Design Review Report

Rev.Design_Review_Report_V1.1

The aim of this document is to describe suggestions and corrections that Quectel advises to improve application that integrates Quectel EG800K module.

- RoviGPS_EG800K_Design Review Report_V2.pdf

3.1. POWER

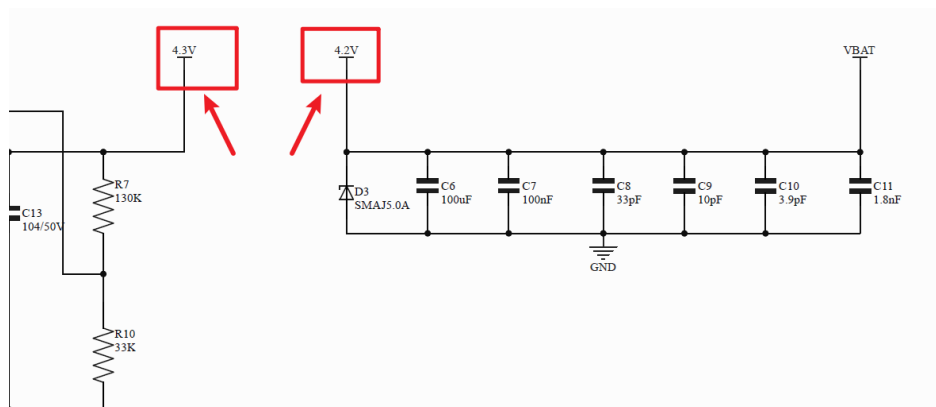
1. Please note that if V_{fb} is 0.8V, the calculated V_{out} would be approximately 3.9V.
Kindly ensure that the regulator calculation is correct on your side.

2. Please note that the voltage from the regulator to the supply source is inconsistent. Kindly correct this discrepancy.

3.2. USB

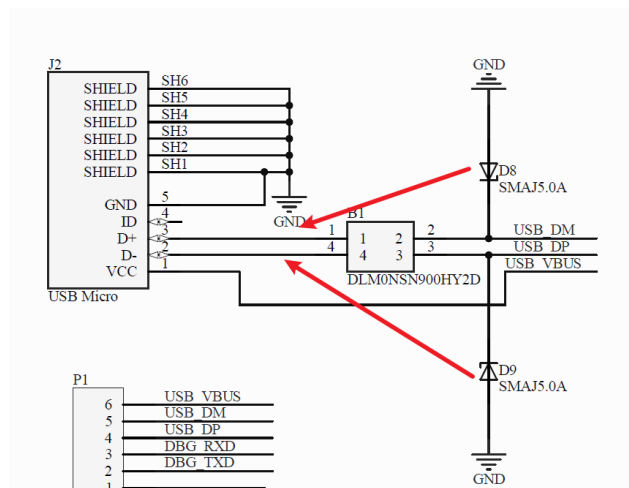
- To protect the USB interface against ESD, it is recommended to add a TVS diode on the VBUS, DM and DP lines. Additionally, the junction capacitance of the ESD protection devices on the USB data traces should be less than 2 pF. The TVS should place close to connector.

3.3. SIM CARD

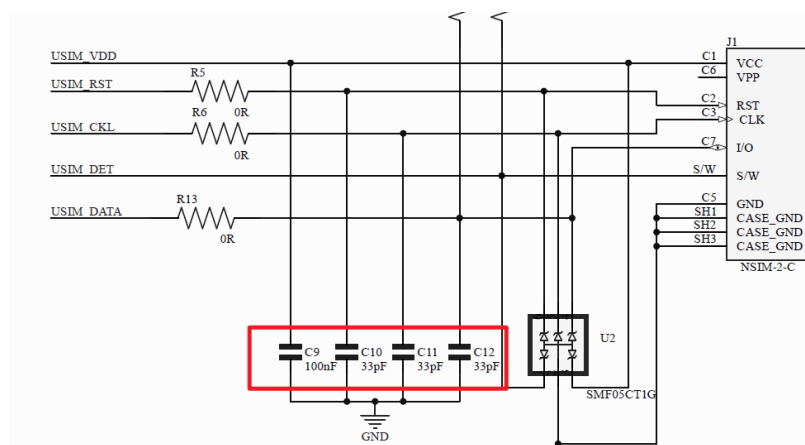
- It is recommended to use a 15kΩ for the pull-up resistor on USIM_DATA instead of 51kΩ.
- To offer good ESD protection, it is recommended to add an ESD protection component whose parasitic capacitance should not be more than 15 pF. Please note that SMF05CT1G is exceed the limit.

- Please note that the previously used values for the filtering and bypass capacitors were correct. Kindly revise them back to the original values.

3.4. UART

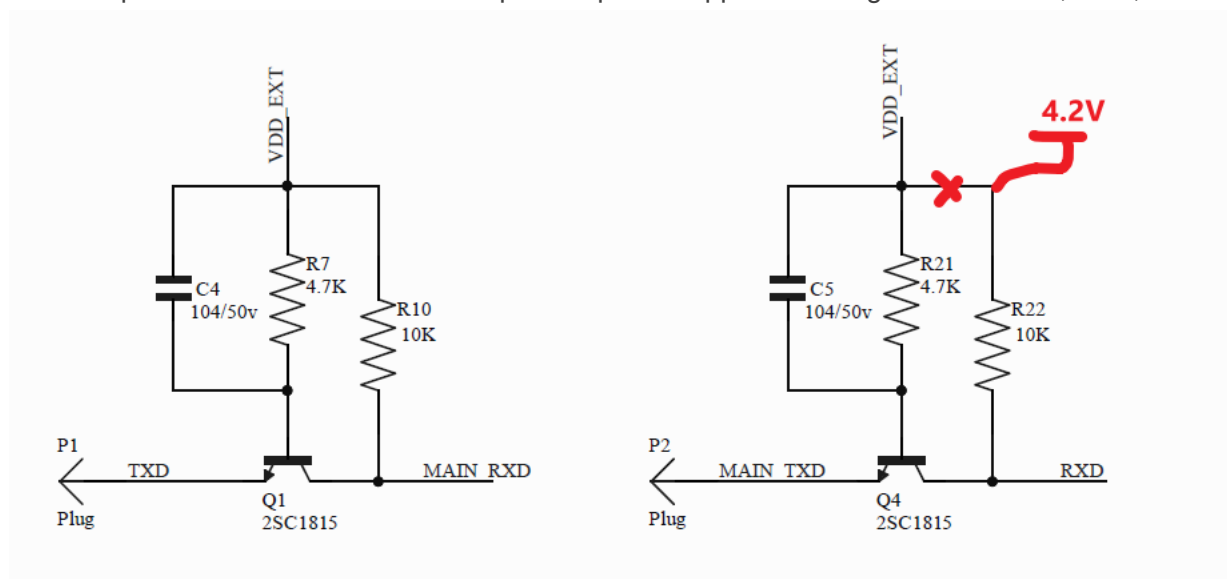
1. Please note that previously the design is correct, however, the RXD signal should not pulled up to 1.8V. It should instead be pulled up to a supported voltage level of 3.3V, 4.2V, or 5V

3.5. OTHERS

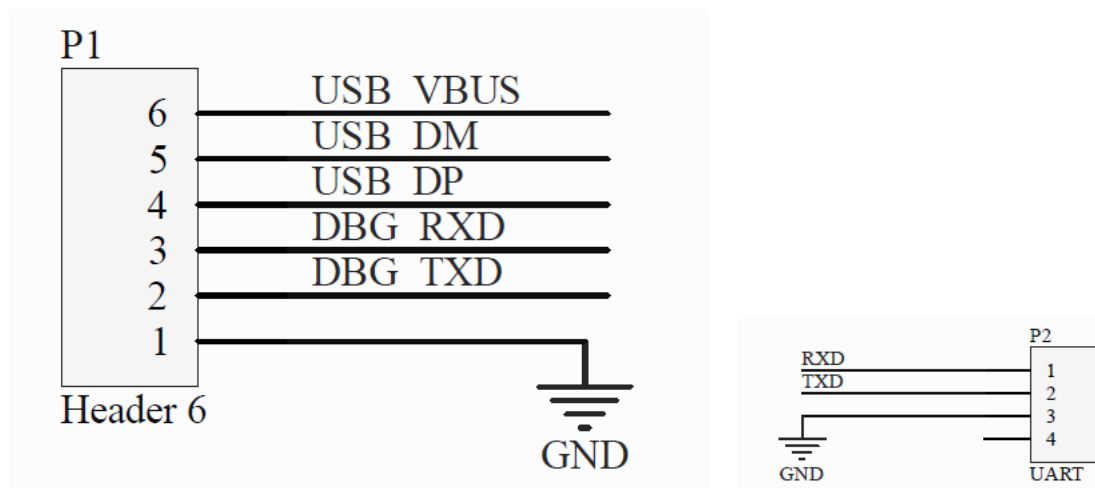
1. It is recommended to reserved a test point at RESET_N.

2. It is recommended to add a TVS diode near the connector for ESD protection.

3. It is recommended to add a TVS diode for ESD protection at all the test points.

3.6. RF

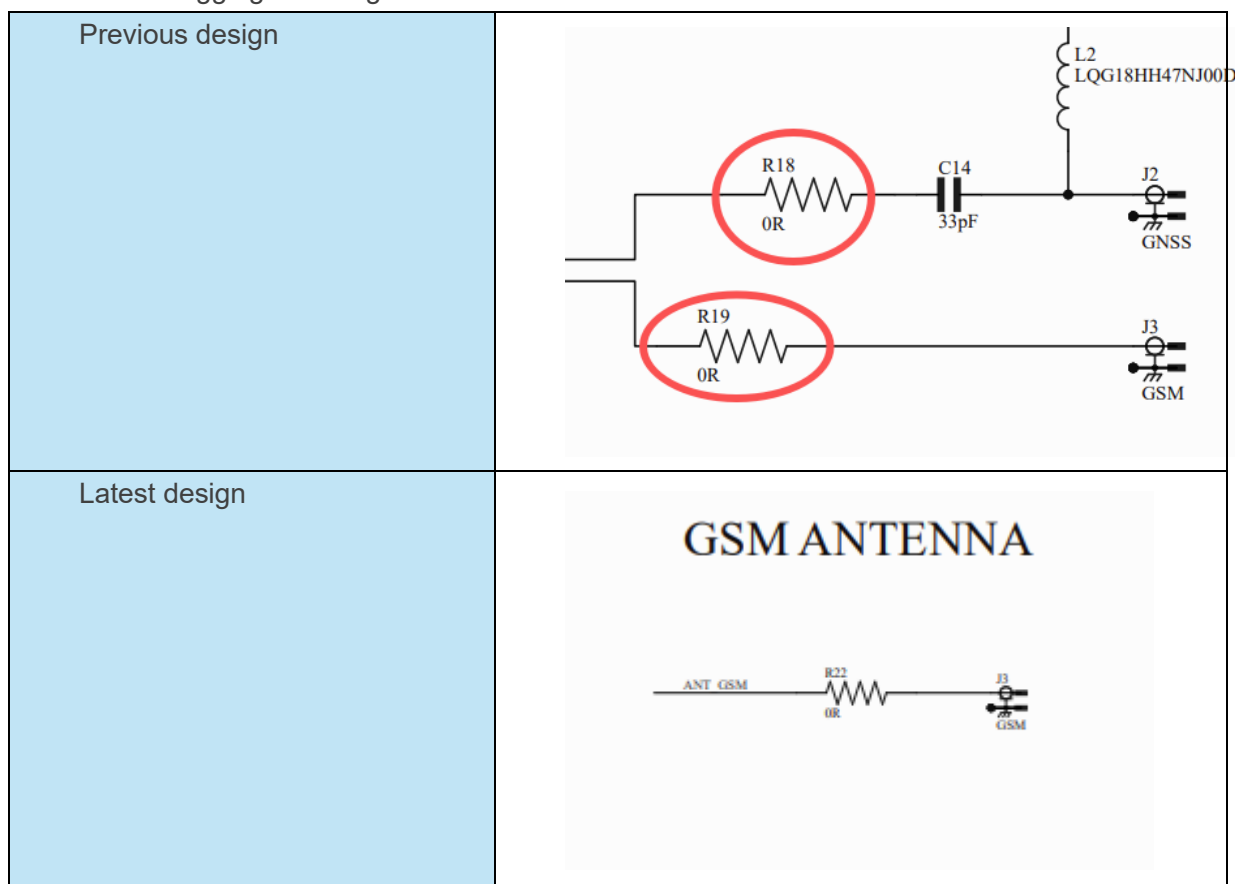
- For 'GSM Antenna' trace, it is strongly recommended to reserve a Pi-matching circuit to facilitate debugging or tuning if needed.

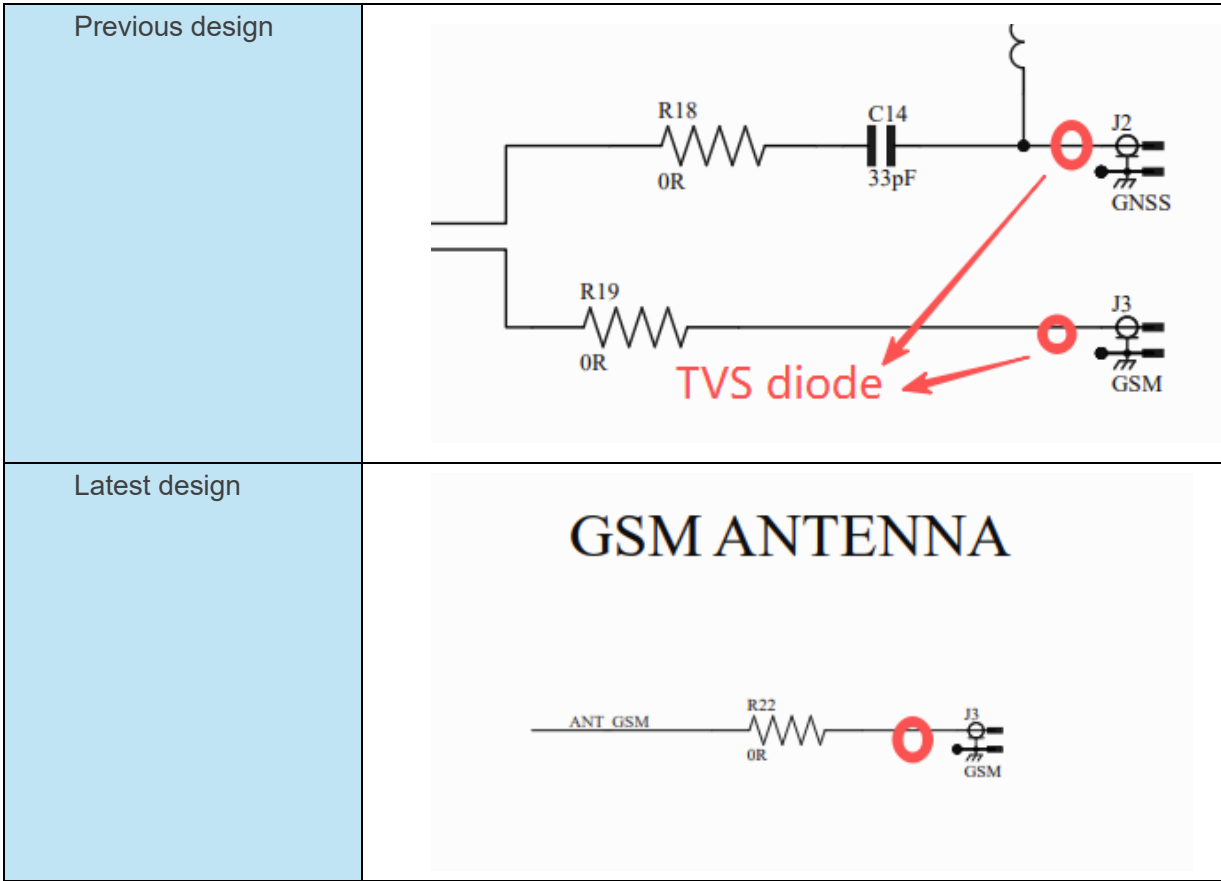
- For GSM antenna trace (ANT_MAIN), it is strongly recommended to reserve a TVS diode for ESD protection. Recommended to ensure that the capacitance junction of the TVS diode less than 0.05 pF for “ANT_MAIN” while “ANT_GNSS” antenna less than 0.5pF.

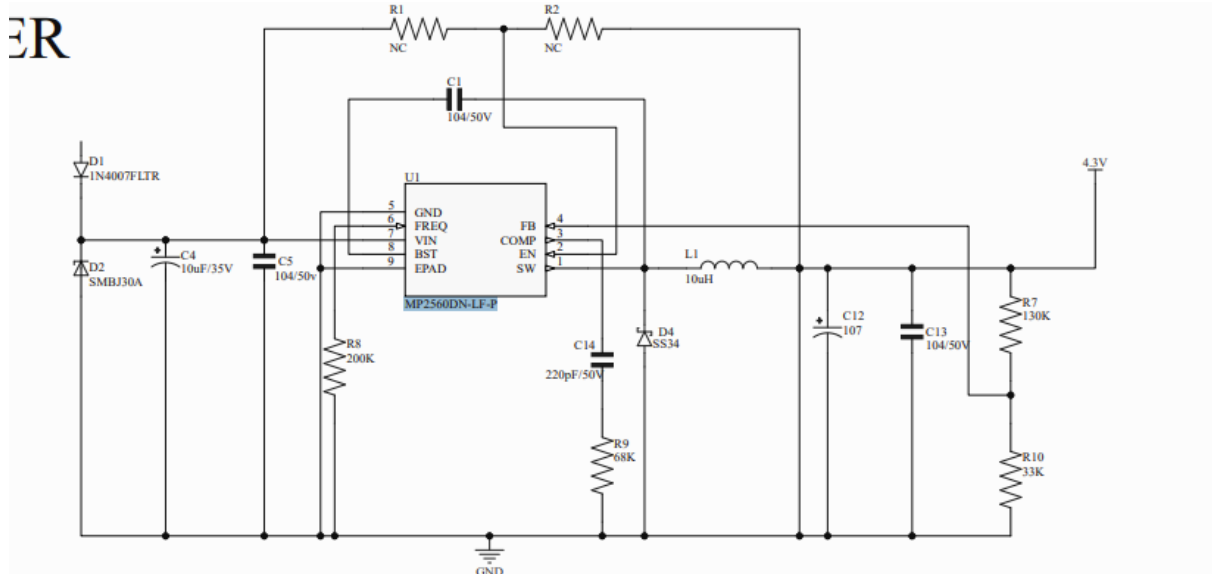
4. During layout design, it's strongly recommended to shield at DC-DC converter with RF shielding cover and reserve spacing for shielding frame.
